City of Detroit
Inter-Departmental Communication

RE: Petition No. 1077
Request to Outright Vacate Alleys IN The Area Bound By first, Plaza Dr., Cass, And Bagley

**REQUEST TO OUTRIGHT VACATE
 PUBLIC ALLEYS BOUNDED BY
 FIRST ST., PLAZA DR.
 CASS AVE. AND BAGLEY AVE.**

DRWG. NO. X 1077

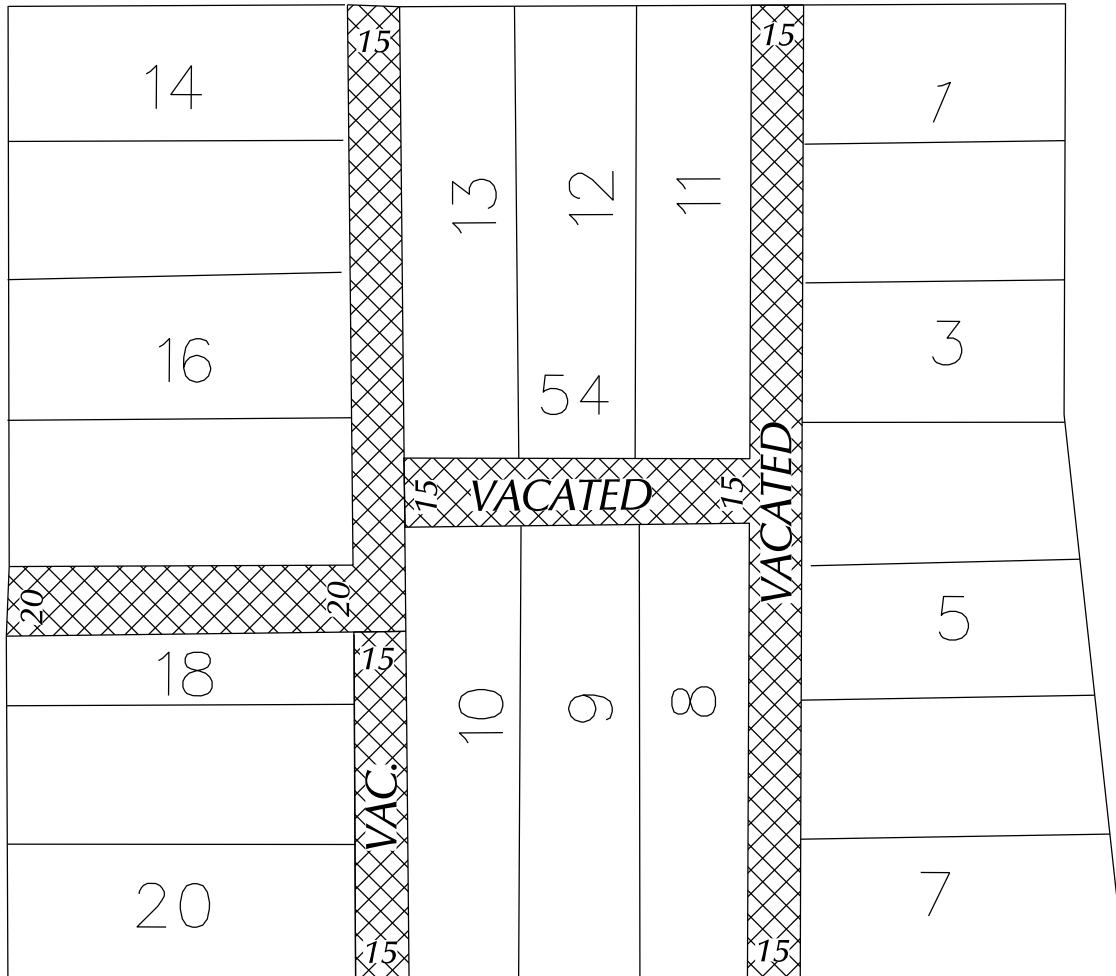
The Detroit Water and Sewerage Department (DWSD) is in receipt of the subject petition. There are sewers and water mains located in the requested outright vacated right-of-way. DWSD objects to the requested vacation unless complete plans are provided to DWSD for approval of the proposed project and the following conditions are met:

- The sewers and water mains service no other properties and only service the properties owned by the Petitioner, and DWSD relinquishes responsibility. If not, the Petitioner must prepare relocation plans for the sewers and water mains signed by a Registered Engineer and must be approved by DWSD.
- The Petitioner is to bear the entire cost of the proposed relocation, including construction, demolition, permitting, inspection, surveying, etc.
- If accepted by DWSD to have ownership of any relocated sewers or water mains, satisfactory easements must be granted by the Petitioner.

The entire work is to be performed in accordance with DWSD specifications and standards, all of the fees are to be deposited with DWSD in advance, to cover the necessary costs of permits and inspection.
